CITY COMMISSION STAFF REPORT

Delray Central Master Development Plan

Meeting	File No.	Application Type
August 9, 2022	2021-138-MDP	Master Development Plan
Applicant	Property Owners	Authorized Agent
G&C Arbors Investors, LLC	G&C Arbors Investors, LLC	Dunay, Miskel, and Backman, LLP Bonnie Miskel, Esq.

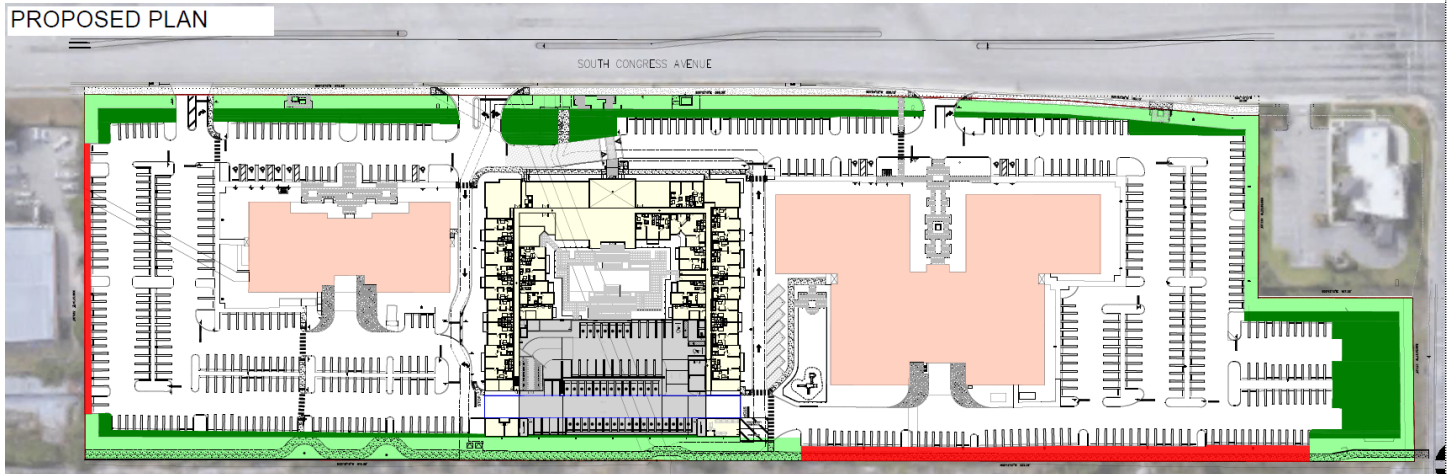
- Landscape Buffer, LDR Section 4.4.29(G)(2)(d): Allow a reduction from the required 15-foot-wide landscape buffer along the south property line to 7 feet and a reduction to the required 25-foot-wide landscape buffer along the east property line, adjacent to the CSX/FEC railway to 15.14 feet. **Note:** the proposed MDP reduces existing non-conformities. The diagram below shows the remaining noncompliant areas in red.

The current landscape buffer depth is an existing non-conformity that is reduced in the MDP. Parking areas are replaced with new buffer areas along South Congress Avenue and parking spaces along the northern property line have been changed to compact spaces allowing a deeper buffer. Two buffer areas will remain non-conforming: the southern property line and part of the eastern property line along the CSX railway. Both areas are not adjacent to the new construction and are depicted in
